AGENDA OF THE PLANNING
COMMISSION
CITY OF BIRCHWOOD VILLAGE
WASHINGTON COUNTY, MINNESOTA
September 24, 2020
7:00 P.M.

CASE NO. 20-04-VB 251 WILDWOOD AVE

TO: Planning Commission
FROM: Tobin Lay, City Administrator
SUBJECT: Variance Case No. 20-04-VB for 251 Wildwood Ave.
DATE: September 21, 2020

4. SHOWING HELICAL SCREW PILES [PERMIT RELATED]:

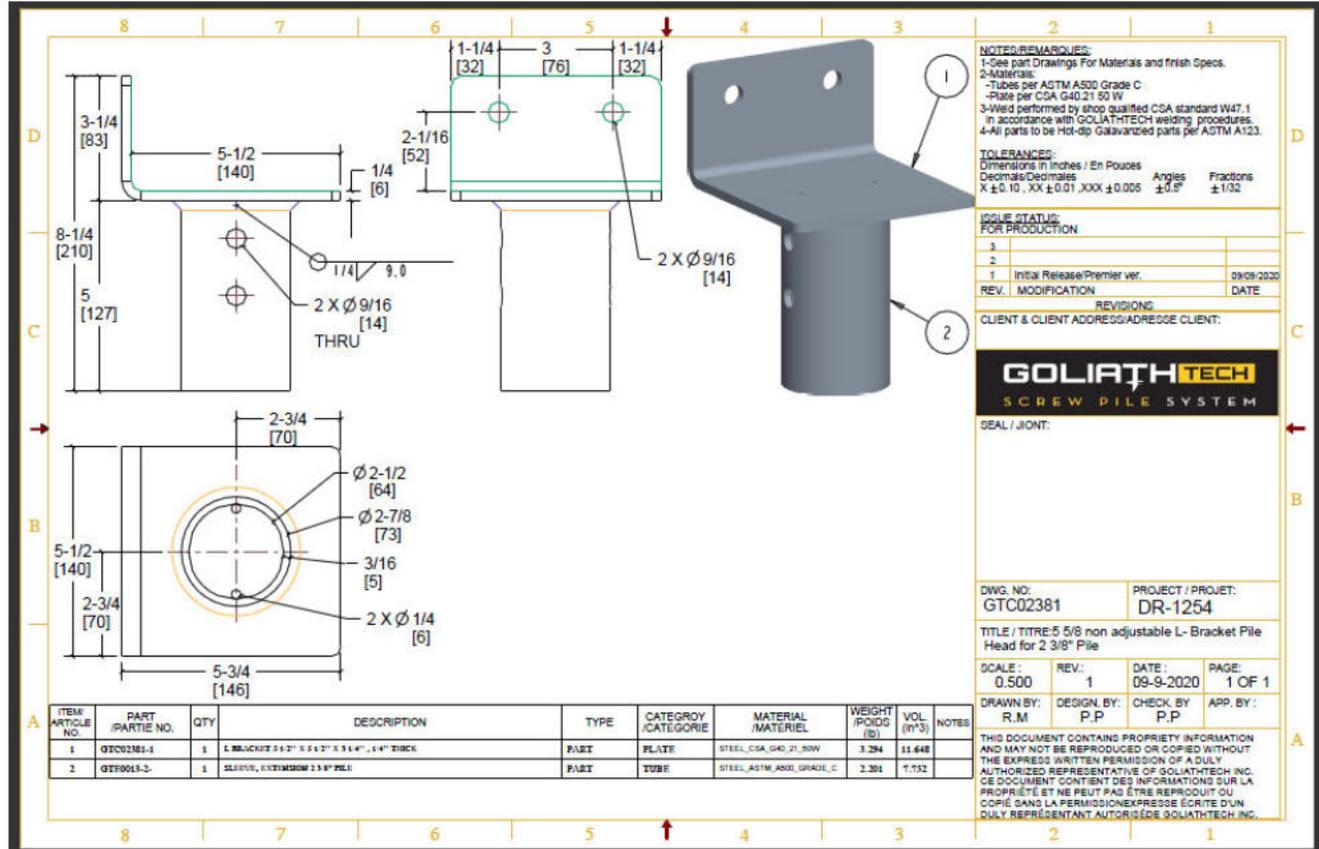
1. It is the opinion of TEI that the proposed Earth Anchor does not meet the requirement of City Code 302.080.2.f "Stairways shall be anchored and supported with pilings or footings."
2. Several local companies have experience installing Helical Screw Piles (example attached). It is the opinion of TEI that Helical Screw Piles installed by an experienced contractor meet the "supported with pilings" part of City Code 302.080.2.f "Stairways shall be anchored and supported with pilings or footings." However, more information is needed to show how the stairways will be anchored to the Helical Screw Piles. You may need an Architect or Professional Engineer to provide that information.

12. SHOWING PLOT PLAN [VARIANCE, PERMIT RELATED]:

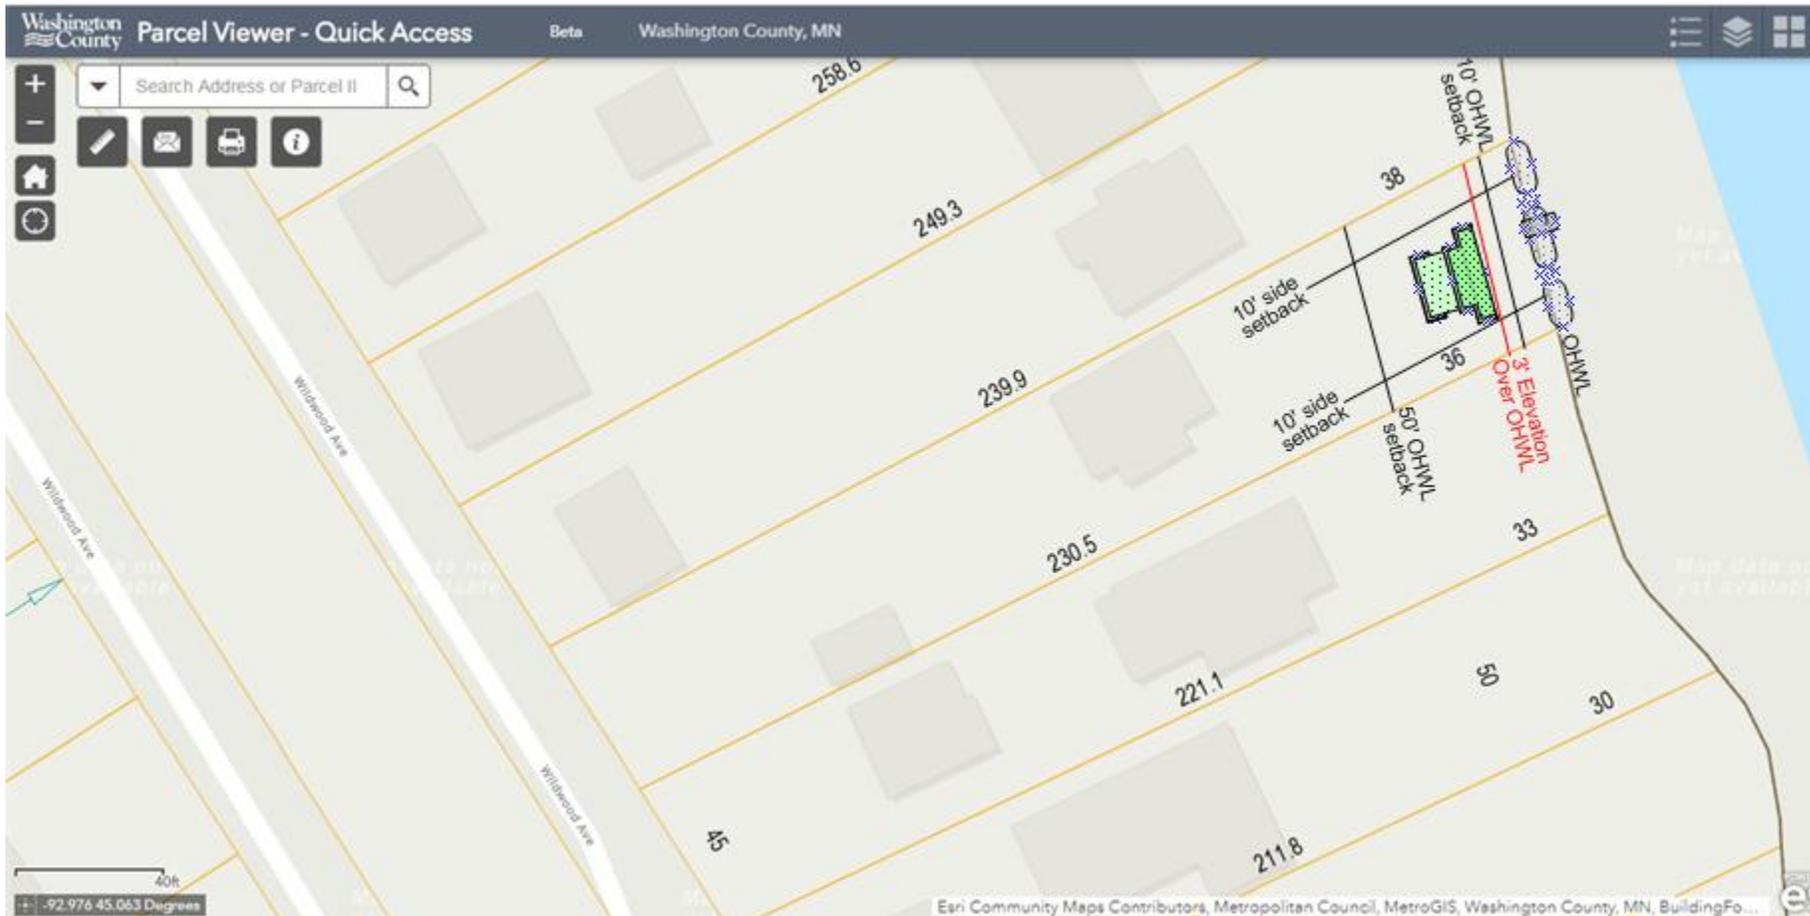
The plan on page A-11 of the Applicant's 38 page supporting document dated September 2020 (attached) shows the retaining walls within the Code required minimum distance of 50 feet from the Ordinary High Water Level (OHWL).

1. This plan was used by Thatcher Engineering, Inc. (TEI) to determine that the distance from the 50 foot OHWL setback to the lake side of the east retaining wall is thirty-five (35) feet. Therefore, the Applicant's request is for a 35 foot variance from the Code requirement.

The same plan (page A-11) shows that grading is needed to install the east (lake side) retaining wall and that this grading is within the City Code required minimum distance for grading of 20 feet from the OHWL.

1. This plan was used by TEI to determine that the distance from the 20 foot OHWL setback to the grading is five (5) feet. Therefore, the Applicant's request is for a 5 foot variance from the City Code requirement.
